PSL - PMC

PMC Servo Rev D

Engineering Change Order History		
ECO number	Date	Originator
1	E010166 to Rev C	RK
2	E010331 to Rev D	RK
3		
4		
5

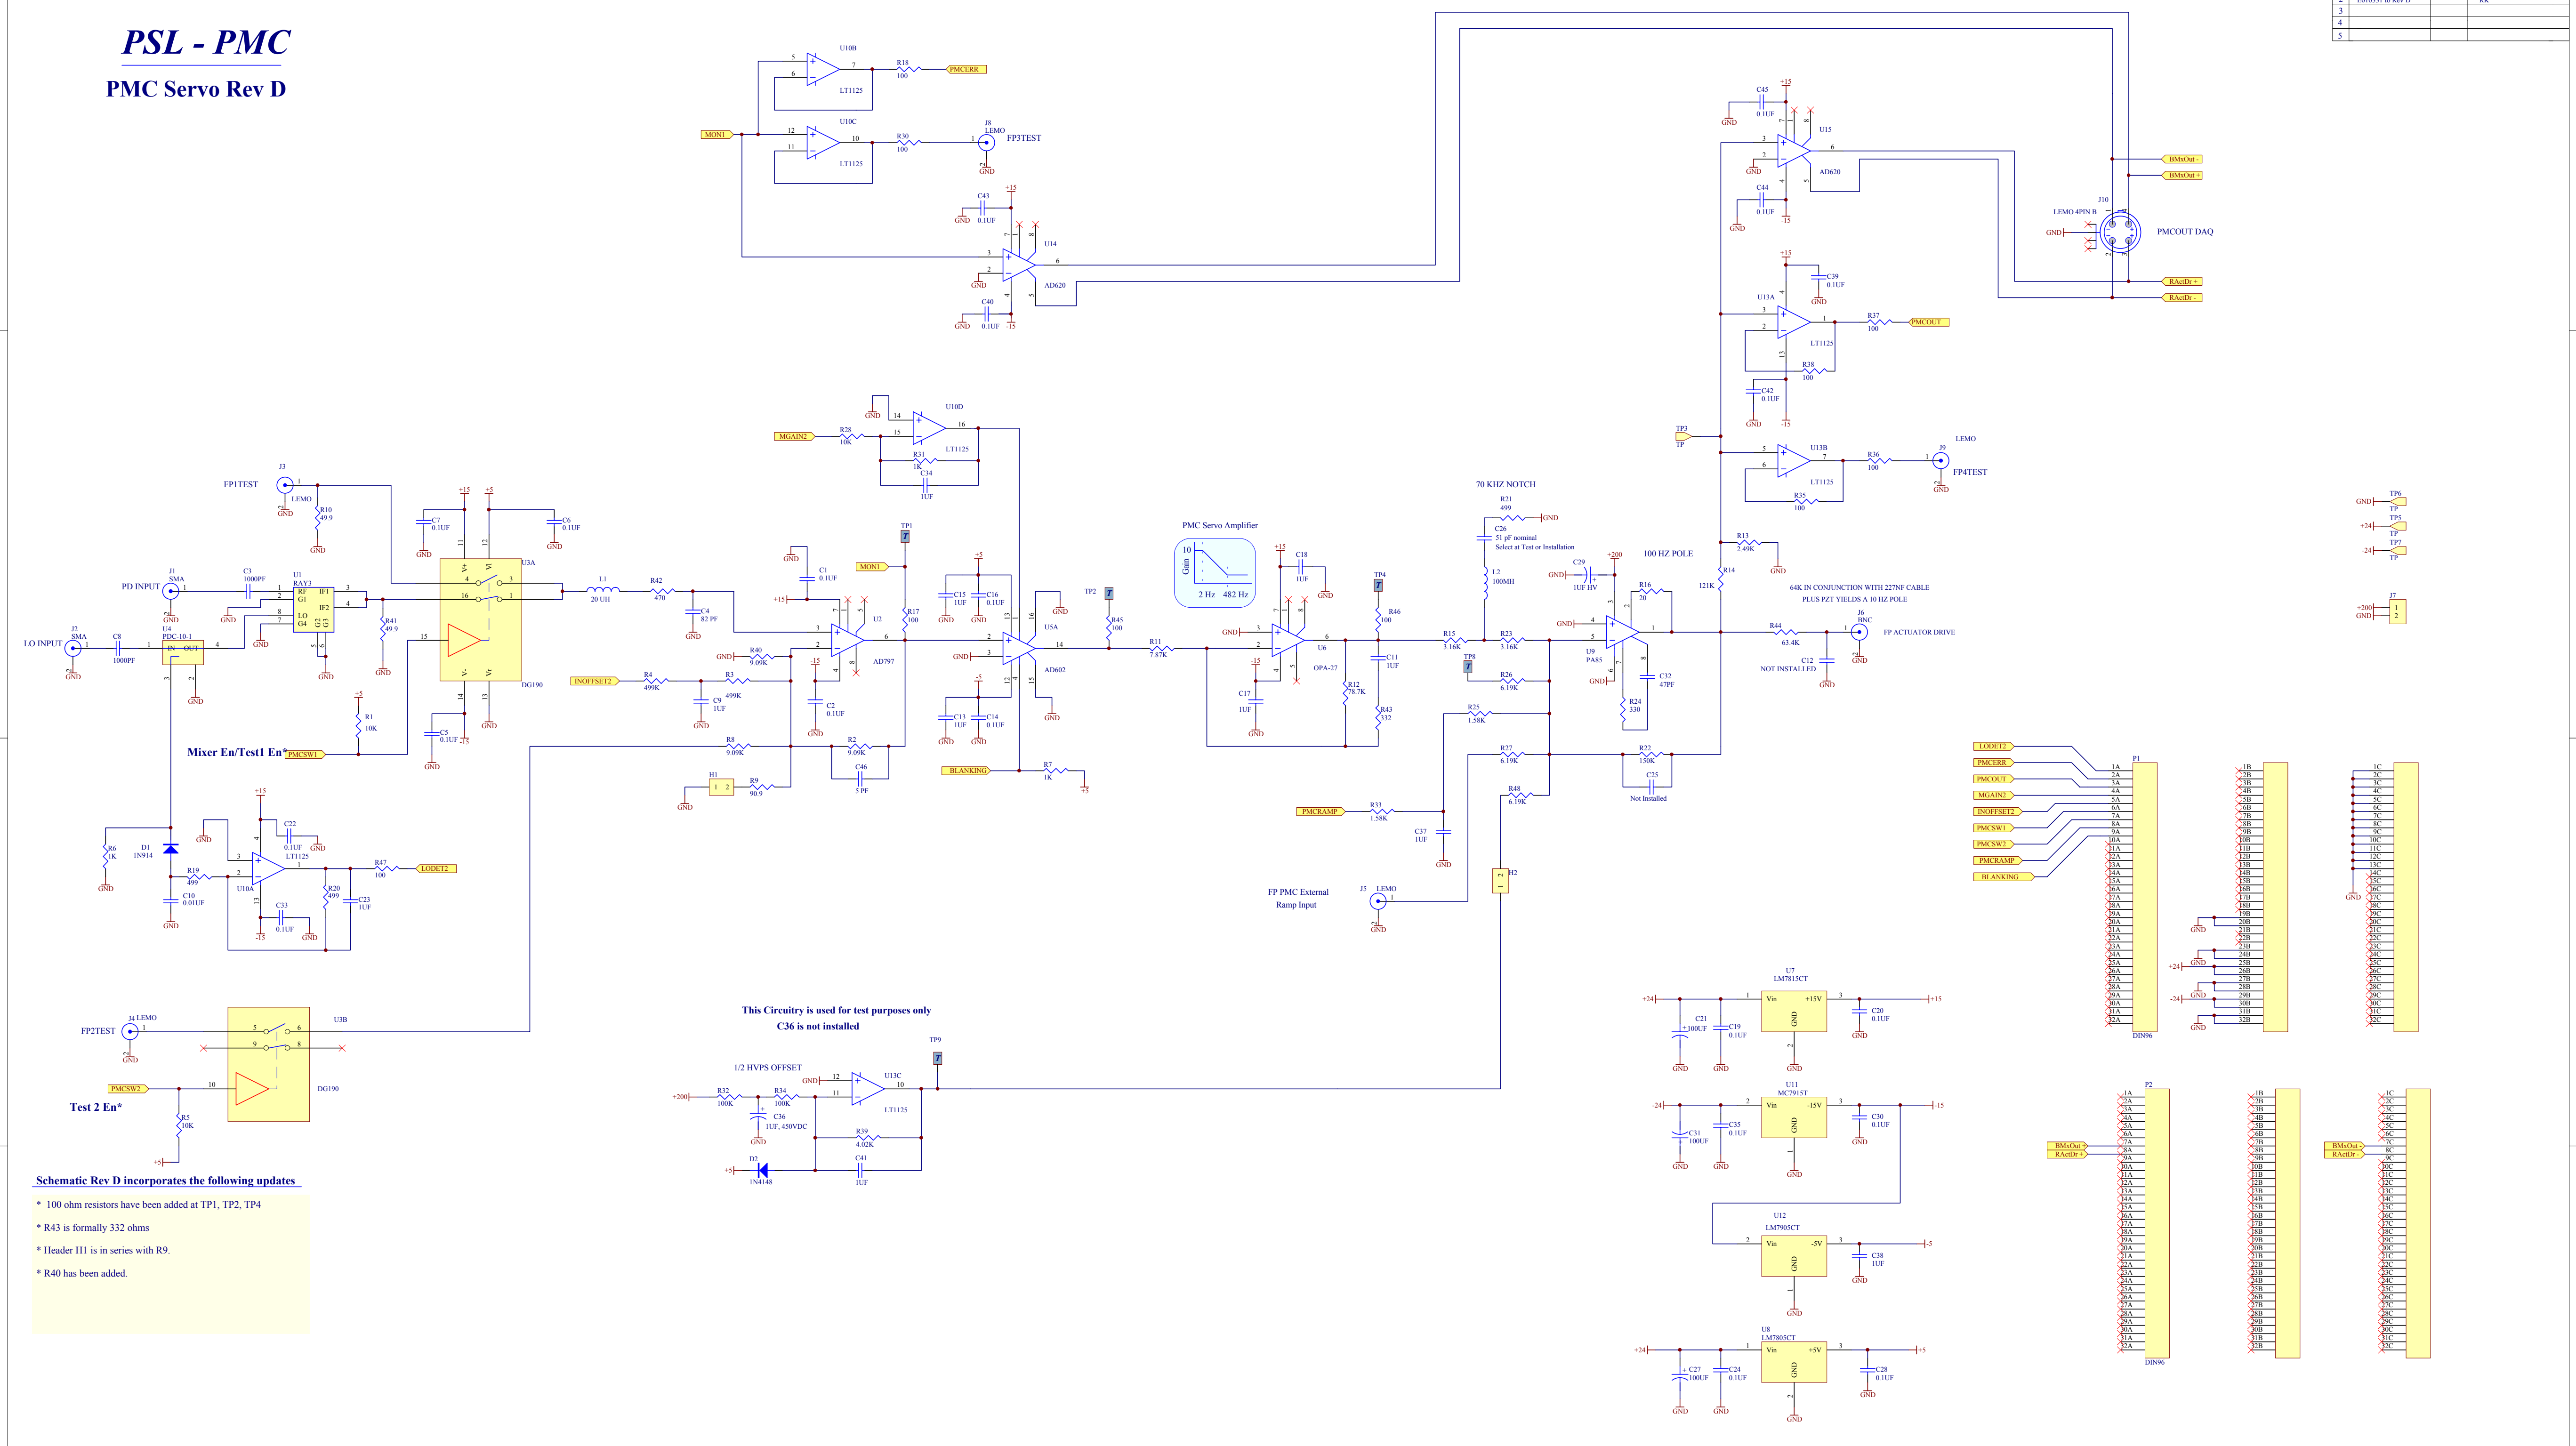
- Schematic Rev D incorporates the following updates**
- * 100 ohm resistors have been added at TP1, TP2, TP4
 - * R43 is formally 332 ohms
 - * Header H1 is in series with R9.
 - * R40 has been added.
